TOWN OF BAY HARBOR ISLANDS

SPECIAL COUNCIL MEETING AGENDA

June 29, 2022 – Approximately 7:00 P.M.

ITEM: Consideration and Approval of an application for an appeal to the Town Council of the Town of Bay Harbor Islands, Florida of a June 7th, 2022 decision of the Design Review Board, denying an application by Bay Harbor Islands Property Owner II, LLC for Site Development Plan Modification pertaining to development at 9431, 9461, and 9481 East Bay Harbor Drive, Bay Harbor Islands, Florida. Enclosed are supporting documents.

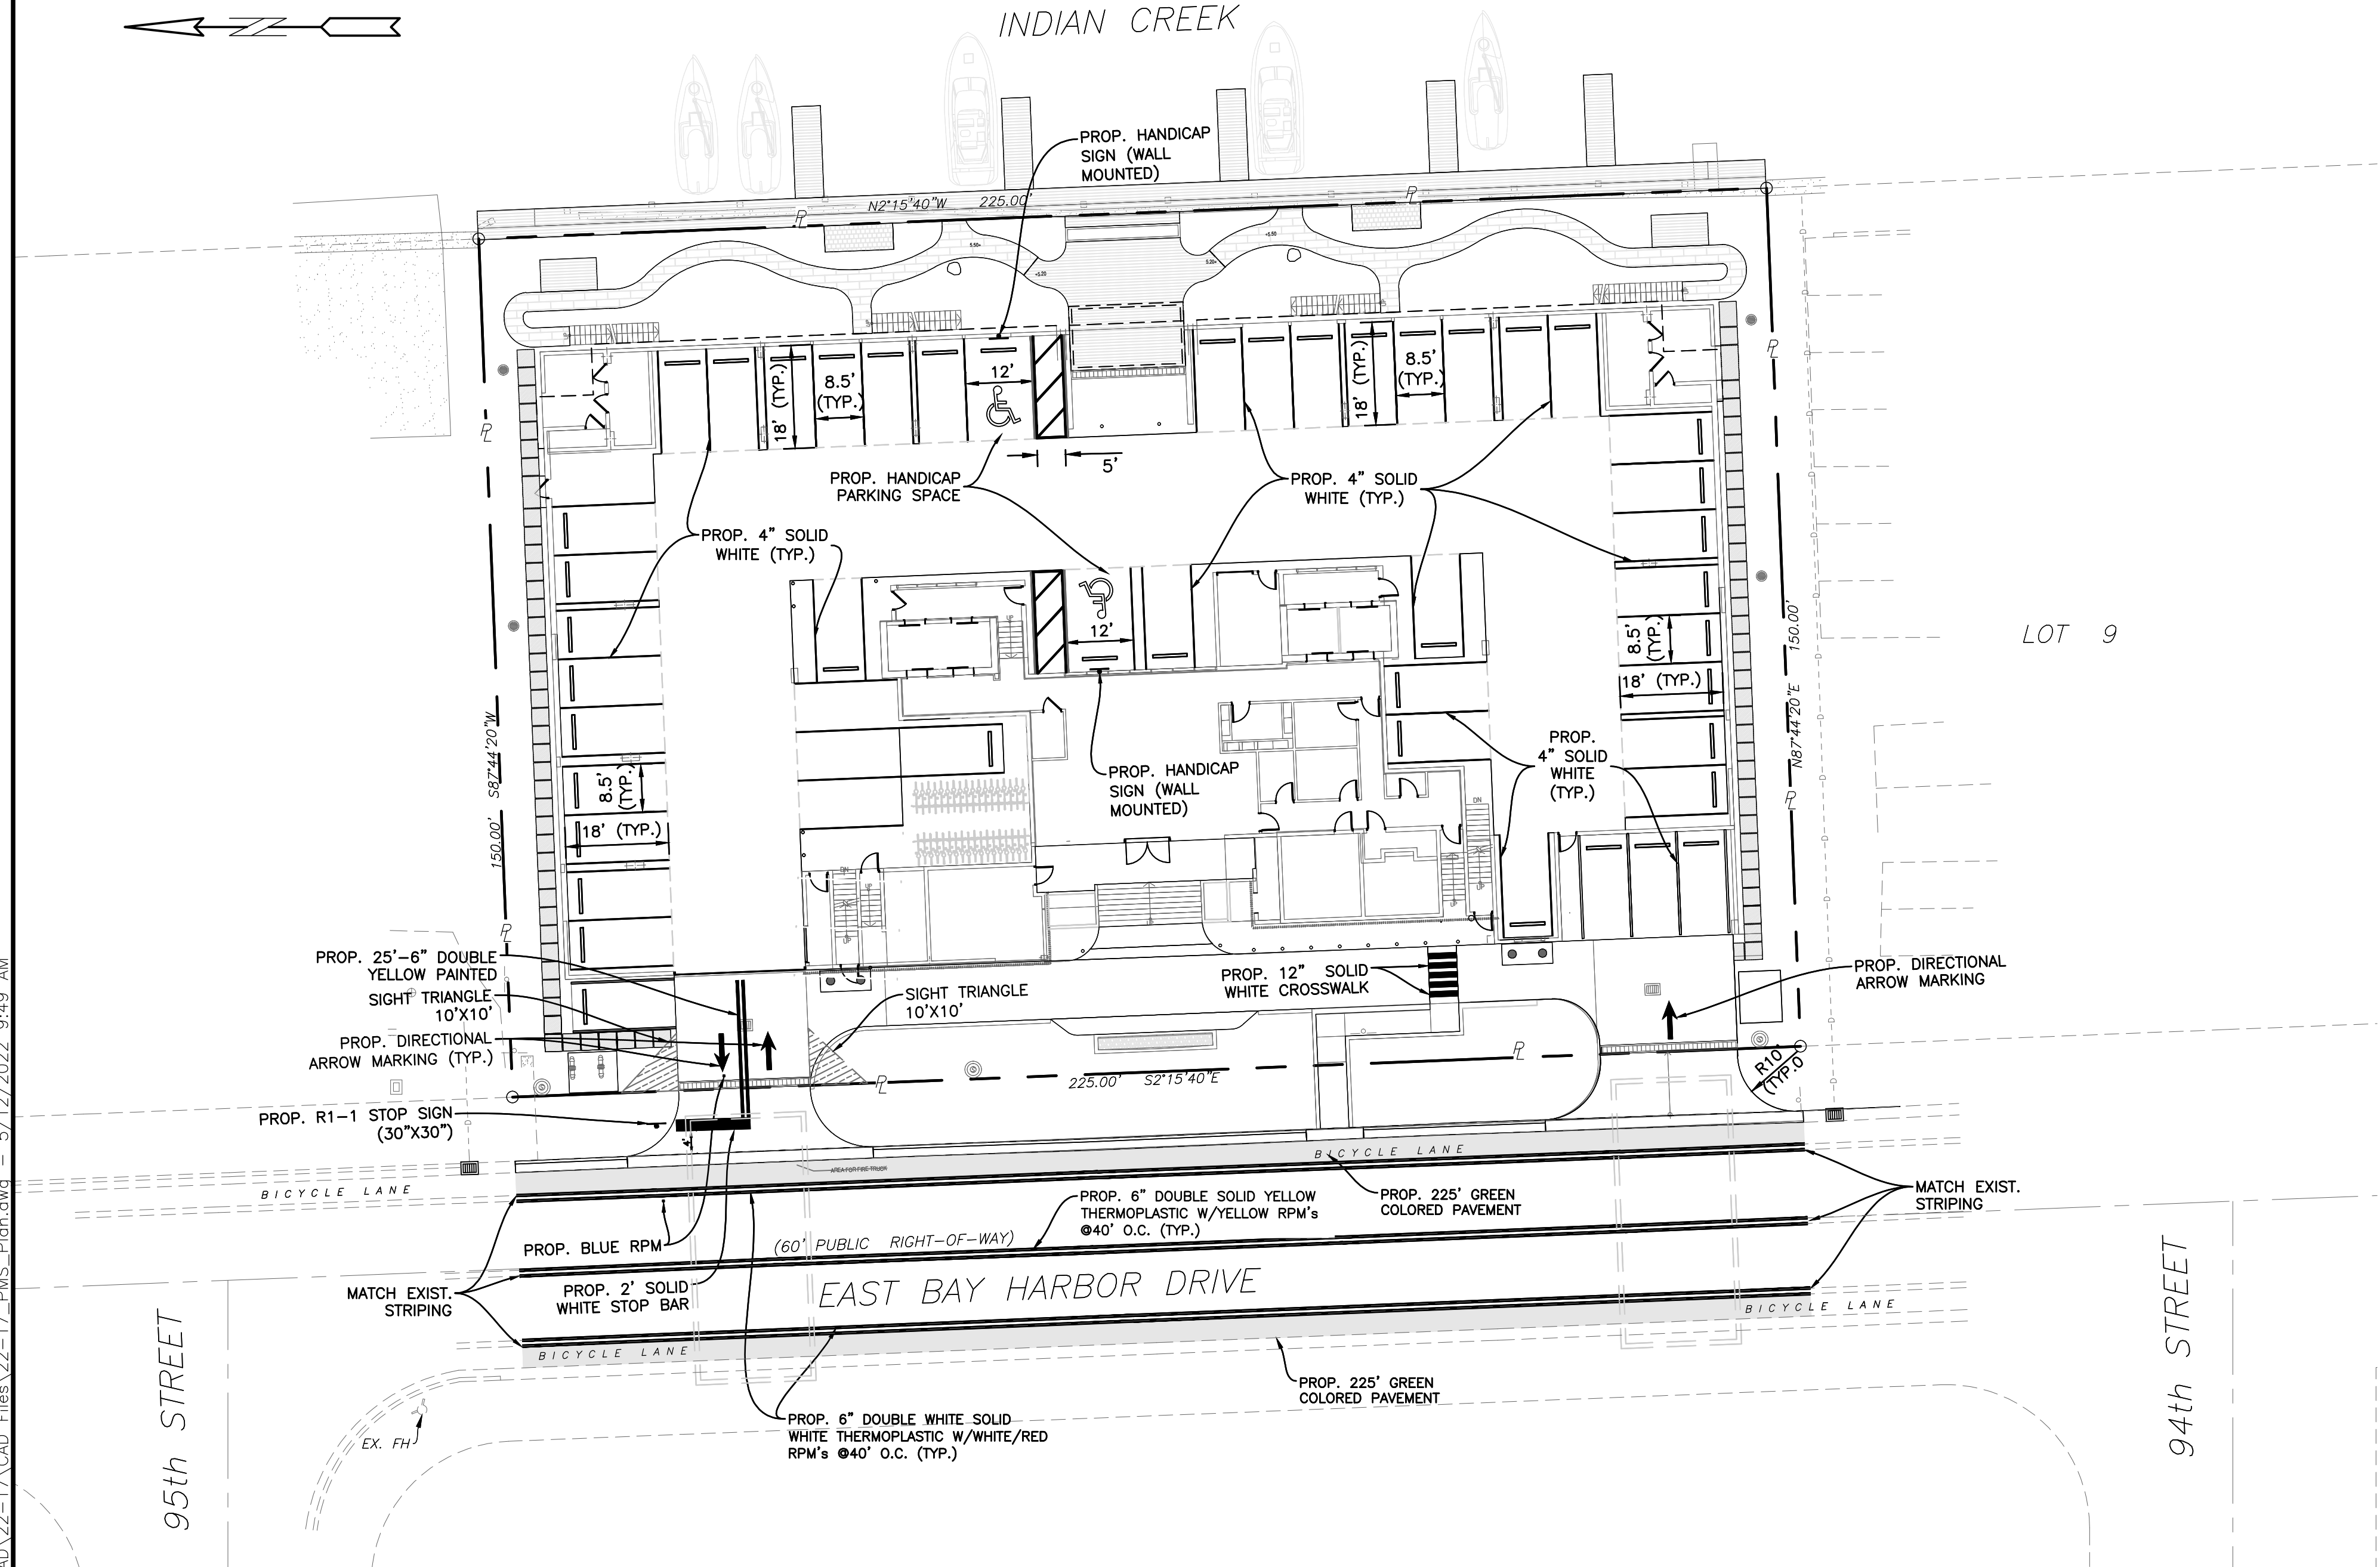
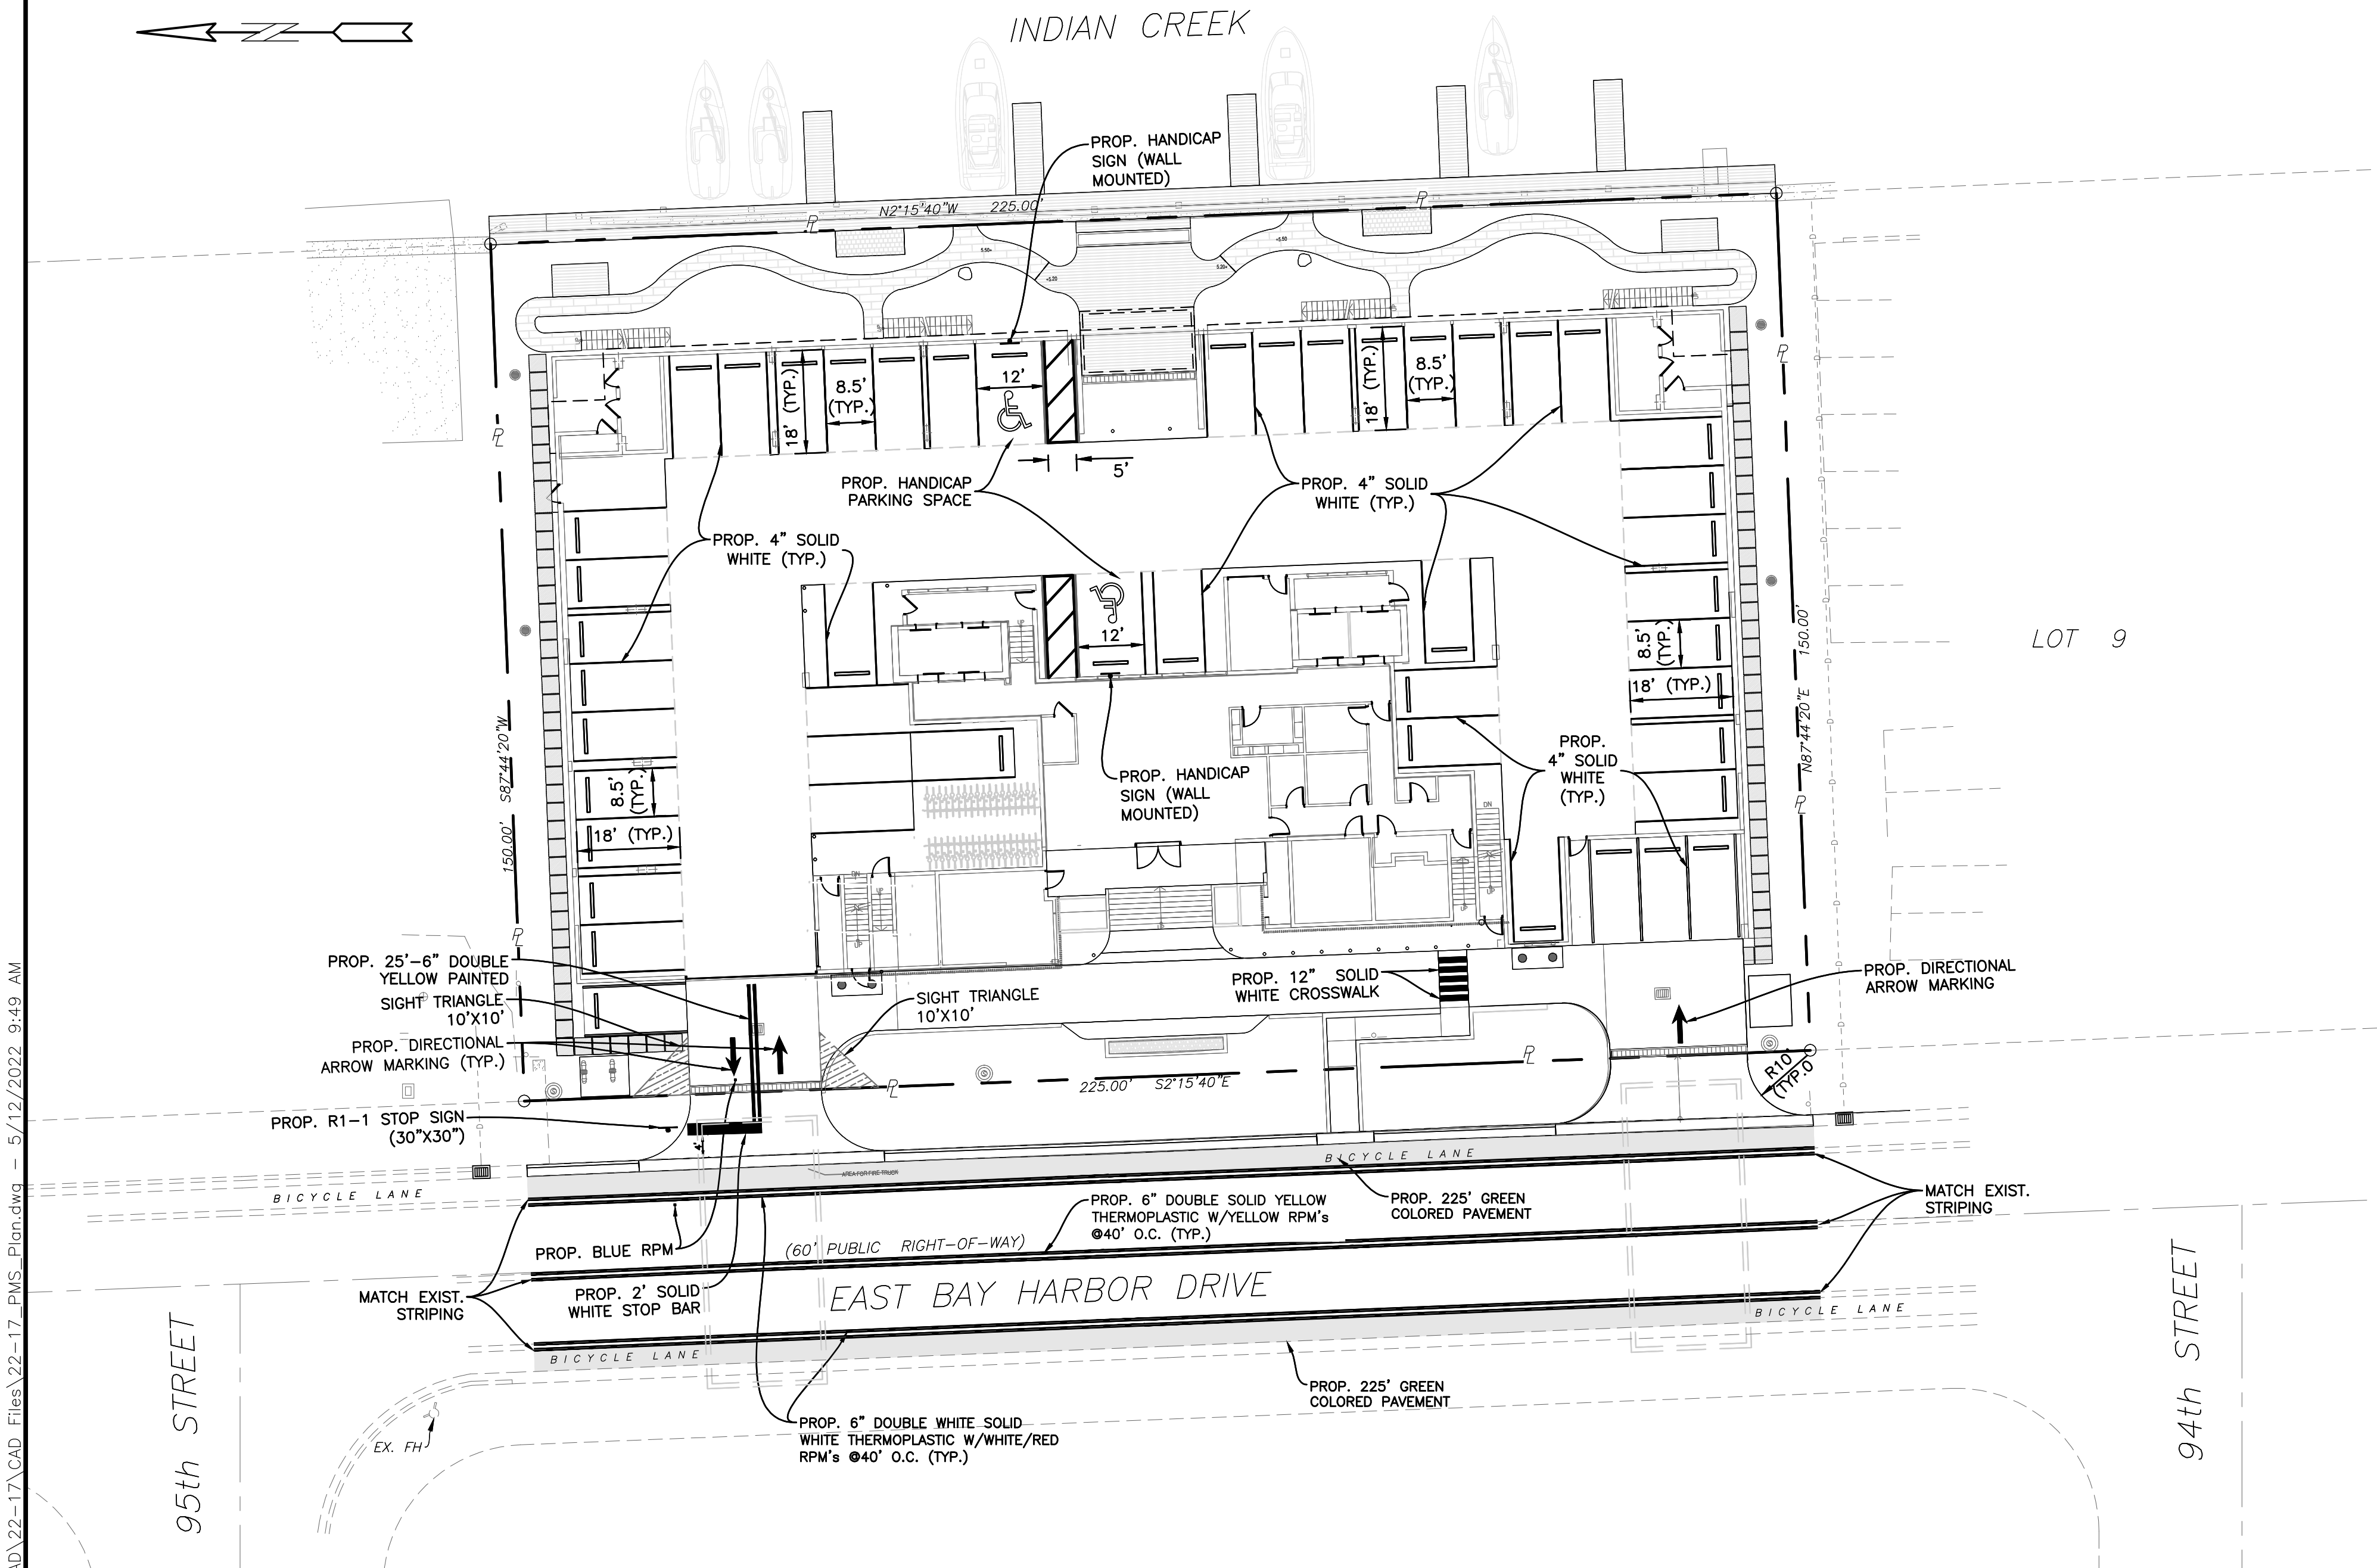
Sheet A-003 Still makes reference to old sheets. There is no detail on sheet C-4 for gravity wall. Comment not needed for DRC approval, but to take into consideration.

1. Sheet A-003 Still makes reference to old sheets. There is no detail on sheet C-4 for gravity wall. Comment S not needed for DRC approval, but to take into consideration.

R: See sheet C-4 for revised details.

Response: The additional sections have been provided on sheet C-4.
